## **D.L. ATCHISON SUBDIVISION**

The plat illustrates the proposed 148.0± acre, 13 lot subdivision, which is located on the North side of Ben Hamilton Road at the North terminus of March Road – within the planning jurisdiction. The applicant states that the site is served by public water and individual septic tanks.

The purpose of this application is to subdivide a metes and bounds parcel into 13 lots.

# DETAIL SITE PLAN

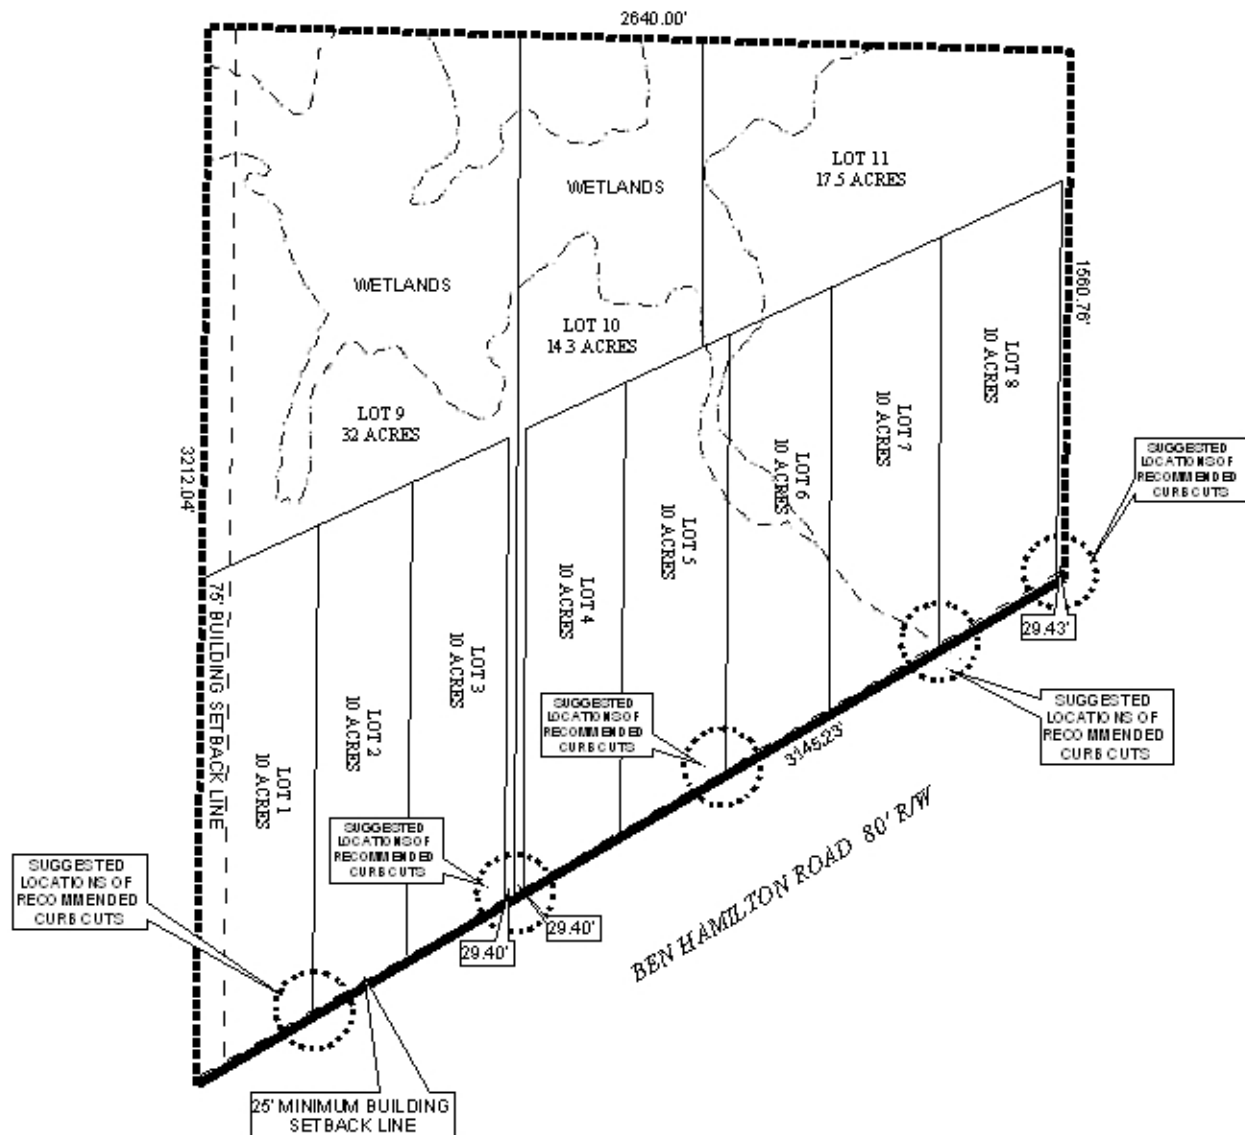
As proposed, Lots 1-10 have 260' – 300' of frontage along Ben Hamilton, while Lots 11 and 12 are flag lots with 25' of frontage each. If approved, a note should be placed on the final plat stating that each lot is limited to one curb cut to Ben Hamilton Road, with the size, location, and design to be approved by County Engineering and in conformance with AASHTO standards.

As mentioned, Lots 11 and 12 are flag lots. Section V.D.1 of the Subdivision Regulations states that “panhandle or flag lots shall generally not be allowed, but may be permitted only in those locations where varied and irregularly-shaped designs are common and the informality of design is consistent with other lots in the vicinity; or, where unusual circumstances such as an odd shaped lot exists; or, separate disparate uses exist on a single lot; or, where there are natural or pre-existing man-made barriers which may cause an undue hardship on the land owner; or in the case of a family division.” None of the aforementioned scenarios pertain to this application. In any event, the “poles” are over 1900' in length, hardly characteristic of any flag lot approved by the Commission in the past. Furthermore, there are no existing lots in the vicinity that would justify proposed Lots 1-10, which exceed the maximum depth allowance of Section V.D.3 of the Subdivision Regulations. The maximum depth of lots shall be 3.5 times the width; the applicant is proposing lots with ratios over 7.5.

However, if approved, the applicant should illustrate a 25' minimum building setback line on all lots (along Ben Hamilton Road); on Lots 11 and 12, the setback line shall be from where the “poles” meets the “flag” portions of the lots. Also, if approved, a note should be placed on the final plat stating that no future subdivisions of Lots 11 and 12 will be allowed until additional frontage on a public street is provided.

The plat meets the minimum size requirement for developments with access to public water and individual septic tanks. However, if approved, it is requested that the applicant revise the preliminary plat to label the lots with their sizes in square feet, or provide a table on the plat with the same information.

- 1) reducing the number of proposed lots to a maximum of 8 lots;*
- 2) increasing the amount of frontage for flag lots to 60' (each) to allow for the construction of a public street; and*
- 3) reducing the depth of any non-flag lots to comply with Section V.D.3 of the Subdivision Regulations.*

*The applicant submitted a revised plat reducing the development to 11 lots, still more than the recommended 8. Additionally, the plat still does not comply with Sections V.D.1 or V.D.3 of the Subdivision Regulations.*

*Without any similar lots in the area to provide justification for the applicant's proposal, the Commission would be hard-pressed to approve this subdivision as presented.*
